Docket Number:	02-AFC-04C
Project Title:	Walnut Energy Center Project - Compliance
TN #:	200101
Document Title:	Walnut Energy Center Authority's Comments on Staff Analysis
Description:	N/A
Filer:	Tiffani Winter
Organization:	Ellison, Schneider & Harris L.L.P.
Submitter Role:	Applicant's Representative
Submission Date:	7/31/2013 4:38:42 PM
Docketed Date:	7/31/2013

SUBJECT: Walnut Energy Center Authority, Walnut Energy Center (02-AFC-4C), Comments on Staff Analysis of Proposed Modifications to the Bridge Water Supply (Condition SOIL & WATER-5)

WECA'S RESPONSE TO THE STAFF ANALYSIS

Figure 1

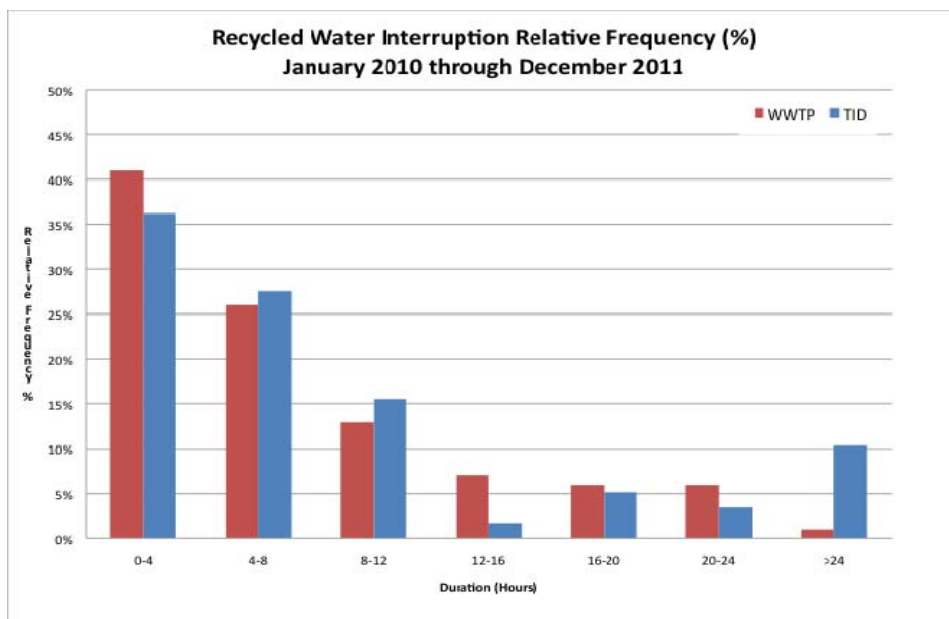
First, the Staff Analysis utilized information provided by the City of Turlock for interruptions of recycled water to the WEC rather than the data provided by the entity regulated by the CEC, the WECA. The City is under no obligation to collect and retain outage data affecting WEC to the same standards as WECA. WECA meters the use of both groundwater and recycled water and can determine precisely when recycled water interruptions occur and when the recycled water is

being received from the City. Below is a revised Figure 1 from the Staff Analysis, which includes the WWTP outage information collected by WEC and the outage data the City provided Staff.

Figure 1 above, shows the difference between the City’s data and WECA’s. WECA firmly believes its data is more accurate for determining the history of recycled water availability to the WEC.

In addition, Staff indicates that extensive disruptions (referred to in the analysis as “extreme event”) experienced by the WWTP were excluded from the Staff’s statistical analysis. The lengths of time for the remaining interruptions (referred to in the analysis as “routine interruptions”) were averaged. For the WEC, any disruption of the WWTP whether defined as extreme or routine, is the same. It results in the WEC relying on groundwater for its water supply and counting towards the CEC’s imposed limit. WECA believes that a backup supply should be available for not only “routine” expected interruptions, but atypical unexpected interruptions as well. Given this, no interruption should be excluded from the analysis regardless of its cause or whether it is considered rare.
